From: Jim Speck [jim@speckandaanestad.com]
Sent: Friday, July 22, 2011 9:08 AM
To: Skaggs, Pam
Cc: 'Dr. Charles E. Brockway'; 'Christine Barrie'
Subject: RE: RE: RE: RE: Barrie Family Partners/Transfer 73608
Attachments: Barrie Family Trust Ponds, Pump & WR B.jpg; 73608 Barrie Family Partners-V3jps.docx

BARRIE FAMILY PARTNERSHIP
Recommended 37-332, & Proposed Pumps
NAIP 2009 AERIAL

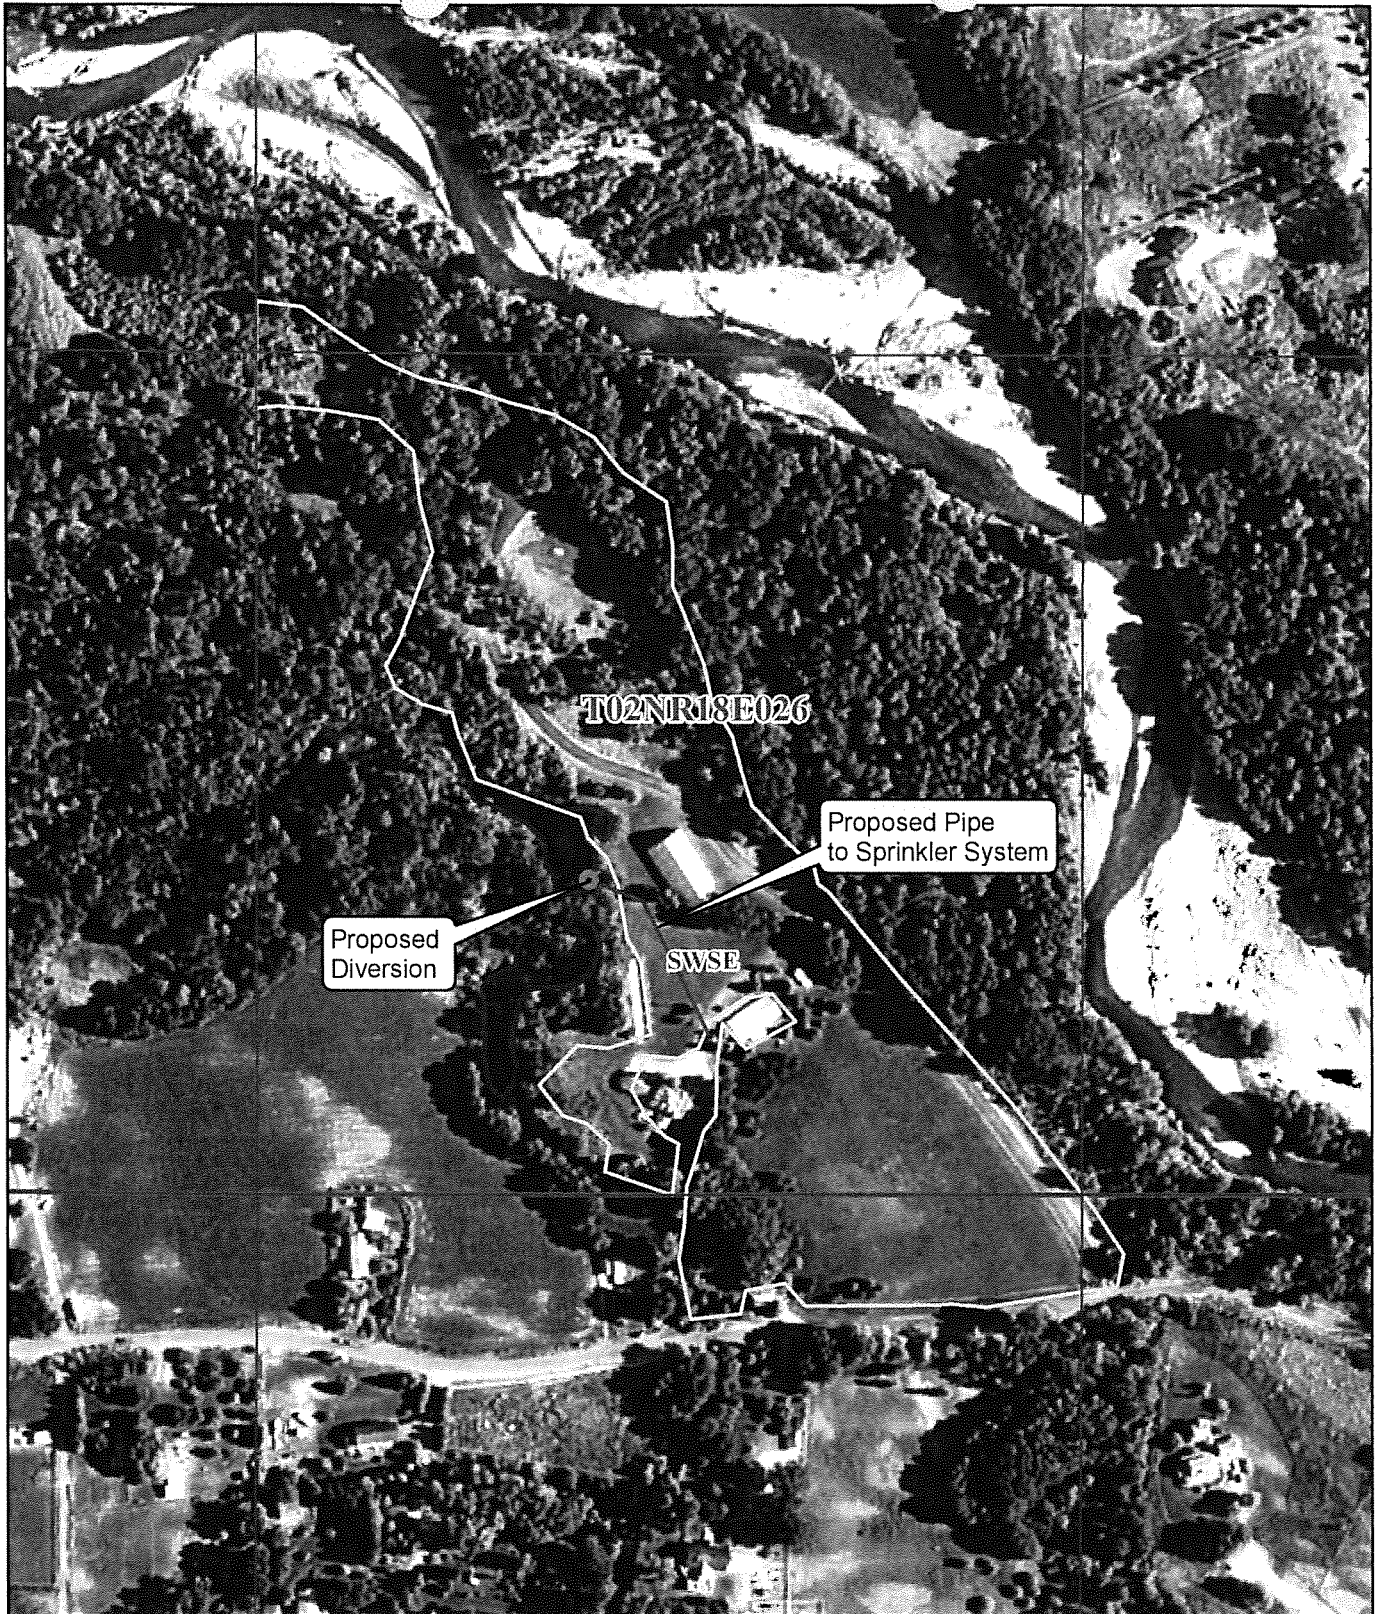
I am enclosing a .shp file prepared by Brockway Engineering showing the location of the proposed diversion from the Broadford Slough in the SWSWSE Sec 26 T2N R18E which is the same location as you have in the draft transfer which is the same 10 acre tract that was in the original transfer application submittal.

The designation of the POD as the "Clearwater Slough tributary to Broadford Slough" is puzzling. No one locally seems to refer to the streams and ponds running through the Barrie property as the Clearwater Slough. However, the ponds appear to have an outlet connected hydraulically to the Broadford Slough. Therefore, we suggest deleting the reference to "Clearwater Slough" in your condition 6.
